IN THE UNITED STATES PATENT AND TRADEMARK OFFICE

Applicant(s): James N. Ray Art Unit: 1762
Serial No.: 10/726,358 Examiner: Brenda Adele Lamb
Filing date: December 3, 2003
For: CELLULOSE PRESERVATIVE METHOD AND APPARATUS

REMARKS

ANNOTATED SHEET

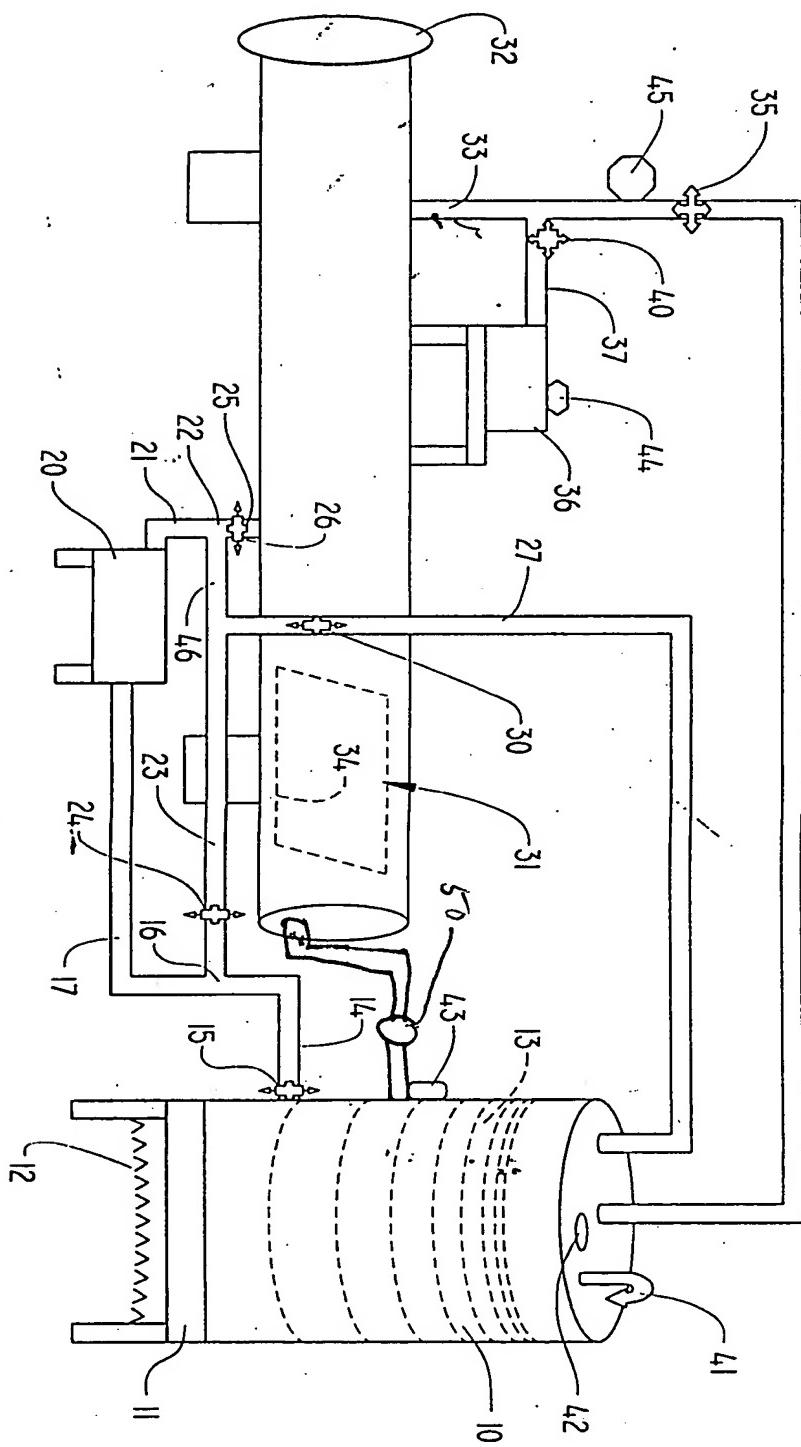
In response to the Examiner's request under 37 C.F.R. §1.83(a) for an amendment to the drawing in the application as filed that will show a discharge pump for selectively withdrawing fluid from the pressure vessel and returning fluid to the work tank, attention is invited to the drawing Replacement Sheet and the companion Annotated Sheet submitted with this response in accordance with Manual of Patent Examining Procedure Section 608.02(v). As now illustrated in the sole figure of the drawing, a pump 50 is connected from the pressure vessel 31 to the work tank 10. As described in the application when filed, at page 10, lines 1 through 4:

In the Replacement Sheet, a pump 50 has been added between the pressure vessel 31 and the work tank 10 to provide this transfer function and the corresponding paragraph in the specification has been amended to reflect the addition of the reference numeral 50.
